Supplemental Report of Steve Nelson
Responses to DWQ Reply on Sunnyside Cogeneration Associates Draft
Groundwater Discharge Permit, with Emphasis on Conclusions and Inferences
Drawn from Previously Unavailable Data

Figure 1. Increase in TDS, Cl, and SO₄ along groundwater flow paths up gradient from and adjacent to the SCA#1 landfill. See text for discussion.

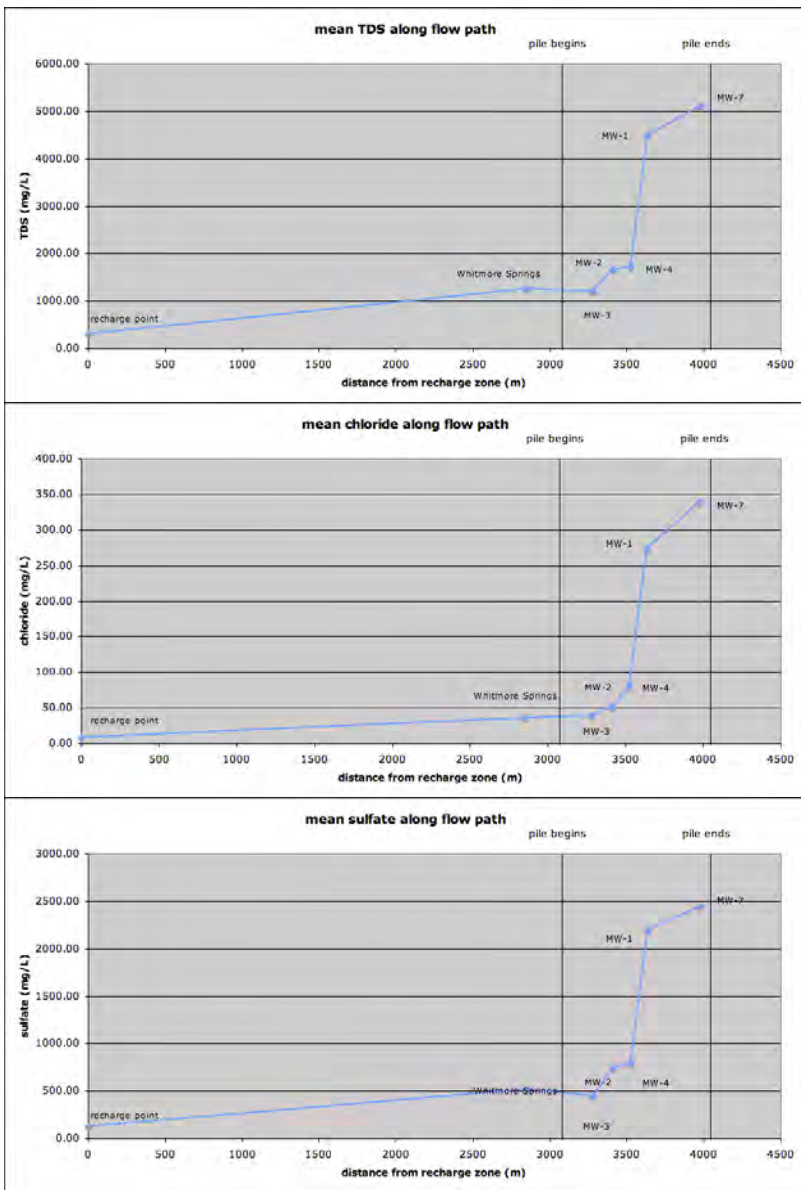
Figure 1 illustrates the rise in TDS (total dissolved solids) and other solutes as groundwater flows from a hypothetical recharge point to and past the pile. It contains a set of conservative assumptions, where "conservative" equates to conditions favorable to SCA.

Whatever one assumes about the time, place, and composition of recharge of this system, it is very hard to believe that the precipitous rise in solute content of the waters in monitoring wells along the pile is natural (Fig. 1). In the dimension of less than 1000 m horizontal distance the TDS suddenly rise by nearly a factor of 5. In my opinion, this is strong evidence that the coal ash landfill is leaking pollutants into groundwater. The similar trends in sulfate, and chloride reinforce this view (Fig. 1). In the case of chloride, there is no sink for this ion (i.e., it is a conservative tracer) and it will travel at the same rate as the seepage velocity of water. There is little doubt that some source or process spatially associated with the pile is greatly affecting water quality in a negative sense.

First, the increase in mean TDS, Cl, and SO₄ down gradient past SCA#1 is based on data collected over the same time interval (Fig. 1). Thus, as discussed above, invoking drought for this magnitude of rise over a 1000 m flow path is not credible as all wells would be affected by dry conditions in a systematic manner. However, additional clear evidence of releases is discussed below.

Figure 2. Normalized concentrations of major solutes in well MW-1. See text for discussion.

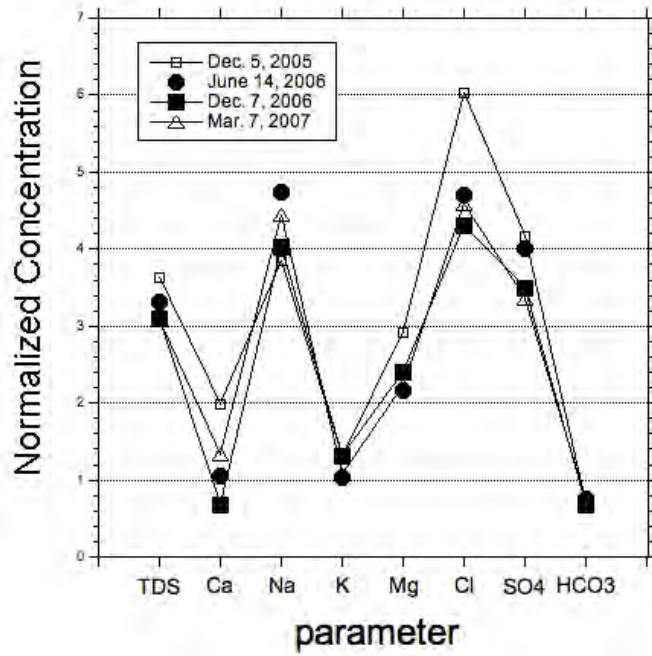
Analysis of four TDS spikes in well MW-1 is illustrated in Figure 2. Using the first five analyses of MW-1 as a "baseline" (mean) composition, the individual groundwater parameters were divided by their respective baseline values. The high, normalized values for certain parameters indicate the addition of an SO₄-rich and perhaps Na- and Cl-rich fluid to this well. SCA's leachate analysis of Feb. 17, 2011 is consistent with very, very high sulfate concentrations. Evaporative concentration, on the other hand, would elevate all parameters equally, unless some process occurred to cause certain constituents to behave in a non-conservative fashion. The several spikes in TDS in MW-1 almost certainly represent transient leakage events of SO₄-rich fluids from the pile near this well⁴.
